**Alternative Technology Advisory Committee  
Meeting Minutes – November 4, 2010**

Rocket Mass Heaters Application 09-002:

Light Straw Clay Application 09-005:

FIGURE R1001.1  
FIREPLACE AND CHIMNEY DETAILS

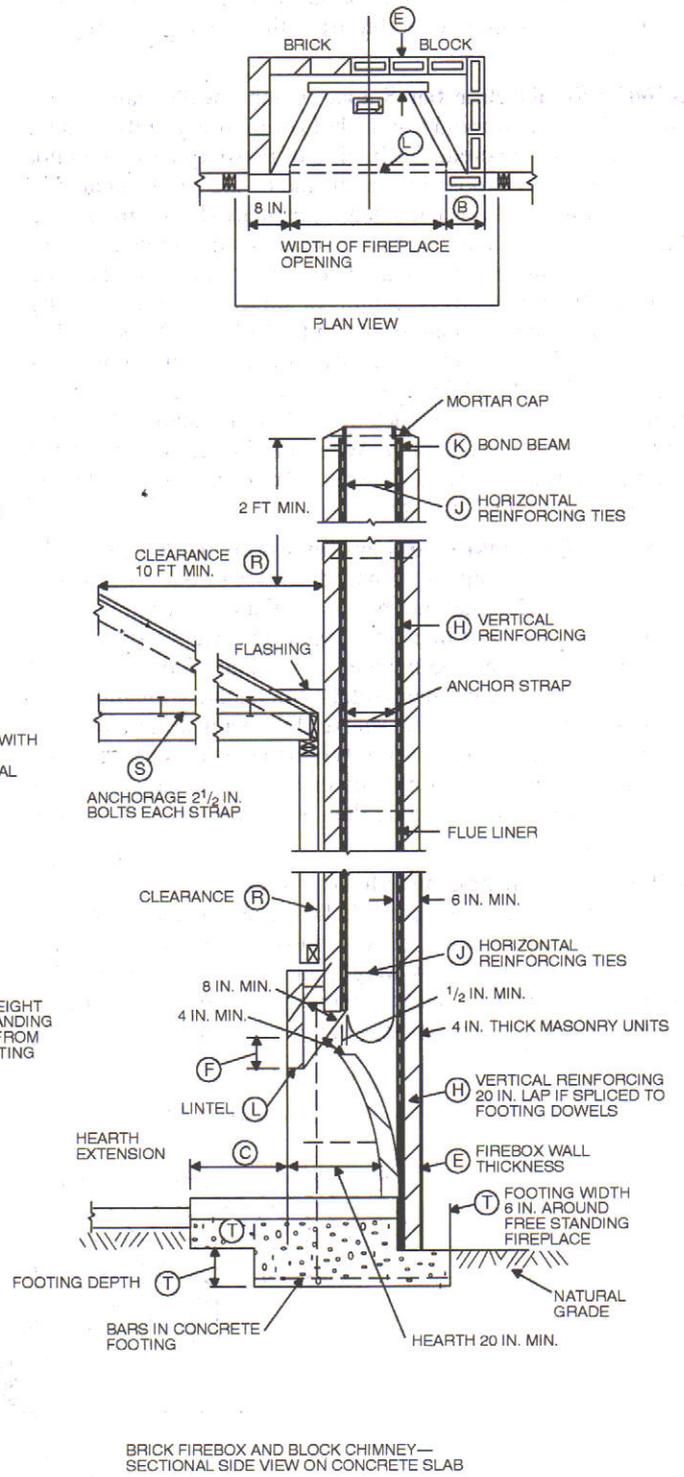
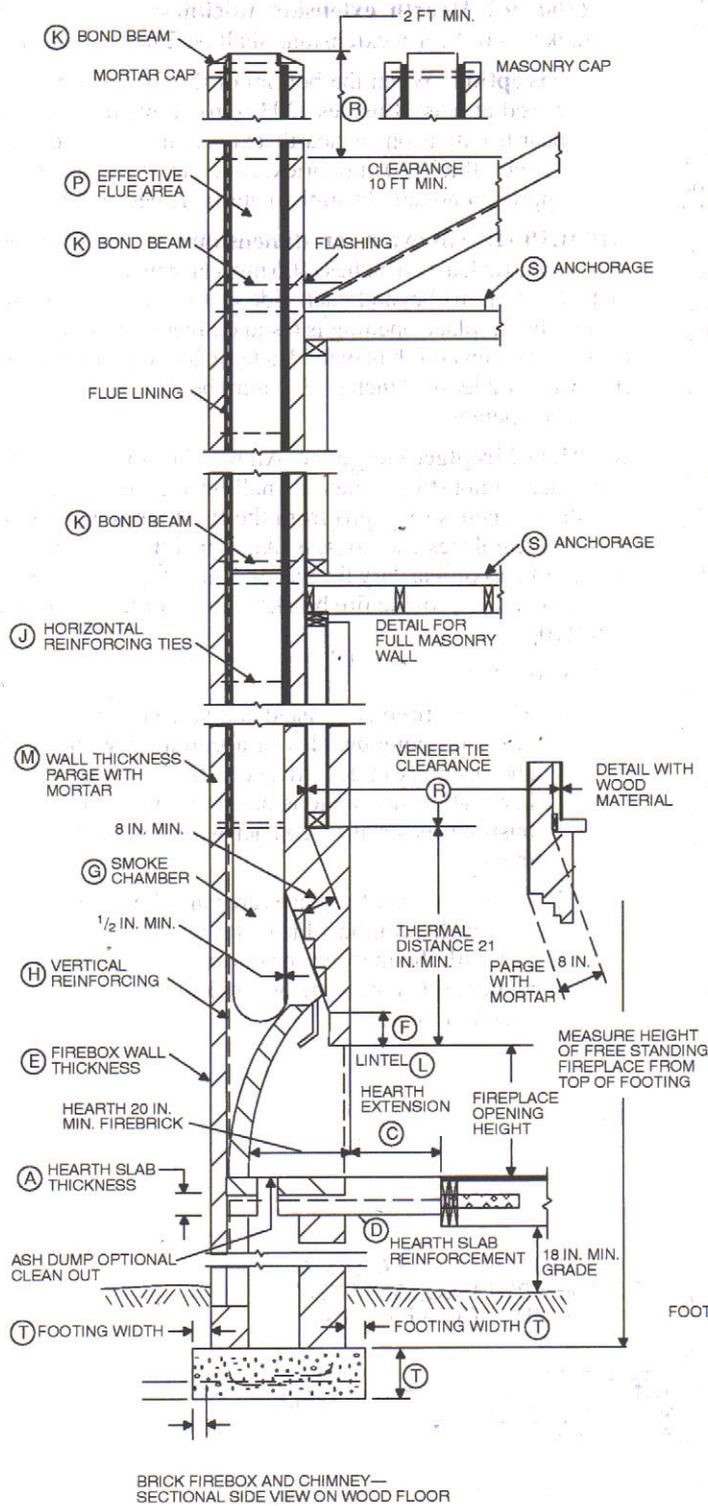
While a substantial amount of work has been done by the applicants in identifying critical points to check during and after construction (as listed on their new website), the committee feels like there needs to be a schematic drawing to accompany the written description. The fireplace/chimney illustration for the current building code is attached as an example. The objective is to give a designer or inspector the critical information for a safe installation but not to be so detailed as to thwart the creative opportunities inherent in rocket stove design. In a previous submittal, the applicants had an illustration that the committee feels like is a good starting point. The written information needs to get tied to that (or similar) illustration.
